## ***IMPORTANT SAFETY RECALL***

Eldorado decided that a defect which relates to motor vehicle safety exists in certain *Aerotech, Aero Elite, and Aerolite* buses manufactured between August 1, 2009 and July 31, 2010 that have A&M Systems Door Headers installed.

## TECHNICAL BULLETIN DOC00039

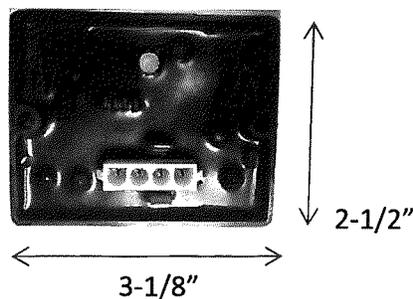
We are aware of one model of PC Board with the potential of over-heating. This PC Board (Model 3230) was supplied to and installed on certain A&M Systems Door Headers manufactured from August 1, 2009 through March 31, 2010. Additionally, PC Boards that were field replaced during this time period could be affected and will need to be inspected. While these reports are few, the over-heating situation could cause the PC Board to burn in extreme cases. As a result we are sending this Technical Service Bulletin to help you identify and replace this PC Board.

**Only the Model 3230 PC Board has shown the potential to over-heat. Please be aware of the importance of this Technical Bulletin. Your prompt attention to this is highly recommended and should be completed no later than December 31, 2013.**

1. The Model Number of the PC Board is located on the Information label that is on the outside edge of the tray.

2. The physical size of the 3230 PC Board Tray is 3 1/8" x 2 1/2". All other PC Board models used by A&M Systems have larger trays.

When you are sure the PC Board is a model 3230 contact the Warranty Administrator with A&M Systems, Inc. at 574-522-5000 ext. 15 to request a replacement board, replace as follows:

1. Remove PC board from Header – PC Board is attached to Header plate with double face tape.
  - a. Unplug the four-pin connector feeding the board.
  - b. Unplug the blue wires from the open limit switch.
  - c. Remove the board by twisting and pulling the board off the header plate.
2. Remove the Information Label from the 3230 Model PC Board showing the 3230 Model number on the label.
3. **Record the following from the removed PC Board:**
  - a. The scribed information from the outside edge of the board \_\_\_\_\_.
  - b. Header Model \_\_\_\_\_.
  - c. Header S/N \_\_\_\_\_.
  - d. Vehicle VIN \_\_\_\_\_.
4. **Cut the two blue wires near the base and using the pre-addressed, postage paid enclosed envelope, send the label, the clipped wire harness and this form to:**

5. **Replace the existing fuse powering the PC Board with a 20 amp fuse.**
